Combined License Application Review Vogtle Units 3 and 4

SER Panel 3

September 27 – 28, 2011

Vogtle Switchyard Configuration

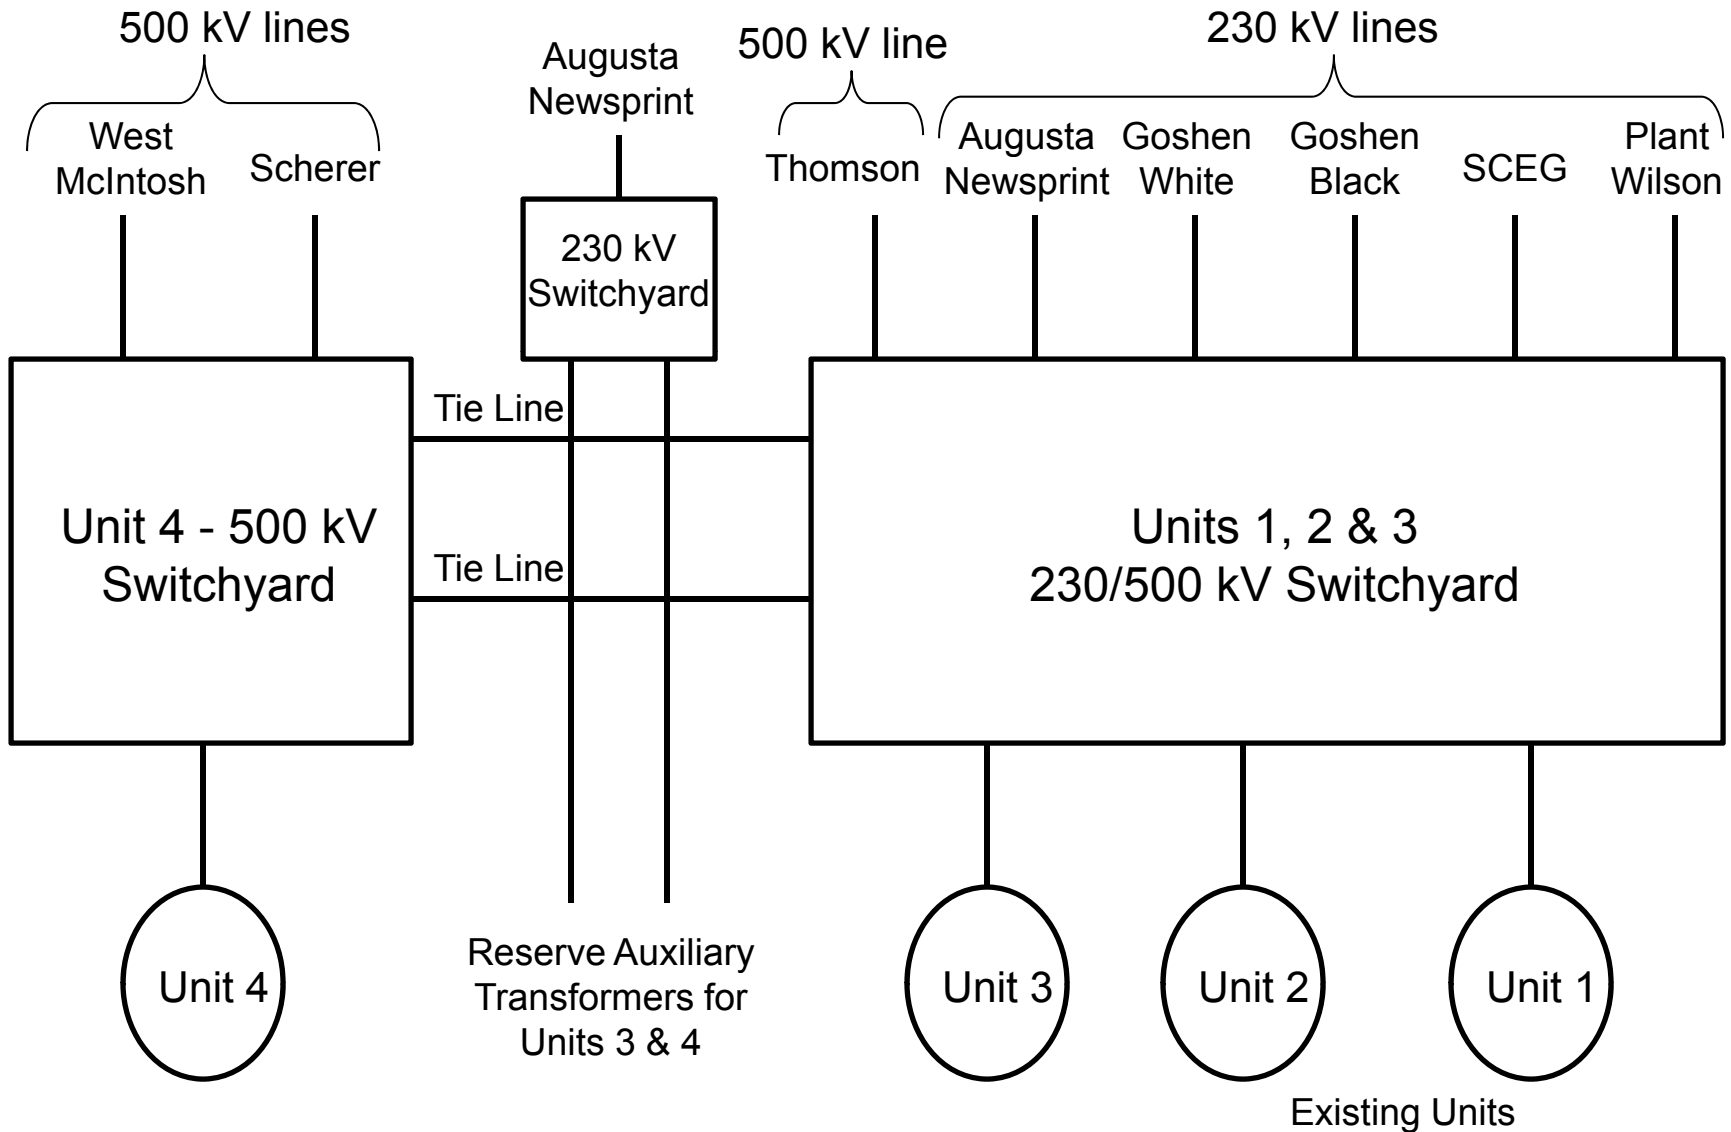
- Unit 3 is connected to the 230/500 kilovolt (kV) switchyard, which is supplied by five 230kV overhead transmission lines and one 500 kV overhead transmission line coming from other substations.
- Unit 4 is connected to a different 500 kV switchyard, which is supplied by two 500kV overhead transmission lines coming from other substations.
- Grid stability analysis was performed by the applicant to satisfy the DCD interface requirement for maintaining adequate reactor coolant pump voltage for 3 seconds after a turbine trip, which was accepted by the staff.
